# UNITED STATES PATENT AND TRADEMARK OFFICE

10/580,006

<b>Office Action Summary</b>	<b>Application No.</b> 10/580,006	<b>Applicant(s)</b> KRISTENSEN, LARS	
	<b>Examiner</b> JESSIE FONSECA	<b>Art Unit</b> 3633

## **DETAILED ACTION**

Fig. 1: Leue et al. (US 3,248,832)

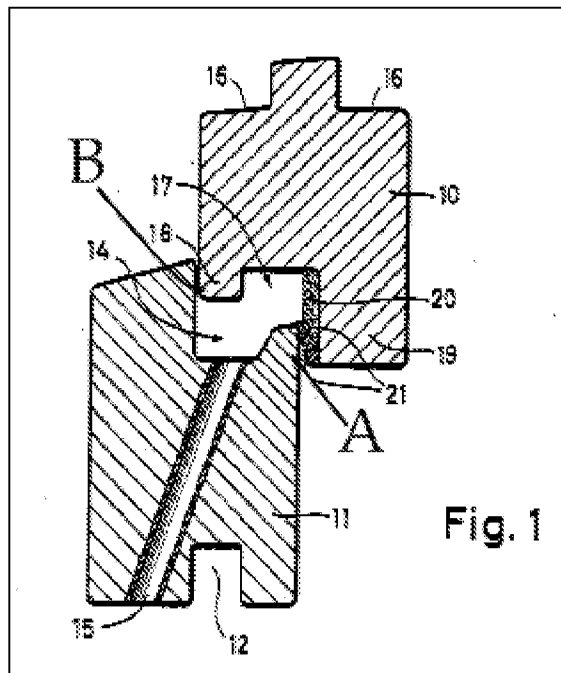
With regards to claim 10 and 19: Leue et al. discloses window frame (11) comprising a window having an inner surface and a sash frame (10), wherein each of the window frame (11) and sash frame (10) include a top and bottom frame member (transverse parts) and lateral frame members (longitudinal parts) (col. 1, lines 33- 39). Leue et al. further discloses a first groove (14) capable of drainage formed in the window frame (11), and a second groove (16) capable of drainage formed in the sash frame (10), wherein the window frame (11) has an inner surface adjacent to the sash frame (10) has an outer surface adjacent to the window frame (11), wherein the first

groove (14) has concave surface extending along the inner surface of the window frame (11) and includes a flange (A) protruding from the inner surface of the window frame (11), and wherein the second groove (16) has a concave surface extending along the outer surface of the sash frame (10), and include a flange (B) protruding from the outer surface of the sash frame (10). Note, the grooves Leue et al. are considered concave as they form hollowed out portions, the drainage grooves of applicant's are considered no more concave than that of Leue et al. The grooves of Leue et al. would be expected to perform equally well to that of applicants. Note the window of Leue et al. is capable of being installed on a roof.

Leue et al. further discloses the window having a covering in the form of a elastic packing strip packing strip composed of foam rubber with plastic cover extending from the window frame (col. 1, line 39-46), but fails to disclose the window comprising a flashing member.

With regards to claim 13 and 20: Leue et al. further disclose the first groove (14) formed in the inner surface of the window frame (11) constitutes a complex channel for the window frame (11), while the second groove (16) for in the outer surface of the sash frame (10) constitutes a complex channel for the sash frame (10). Leue et al. further discloses the cross section of the window frame (11) and sash frame (10) are the same throughout the transverse (bottom and top) and longitudinal (lateral) parts of the respective frames (col. 1, lines 33-39).
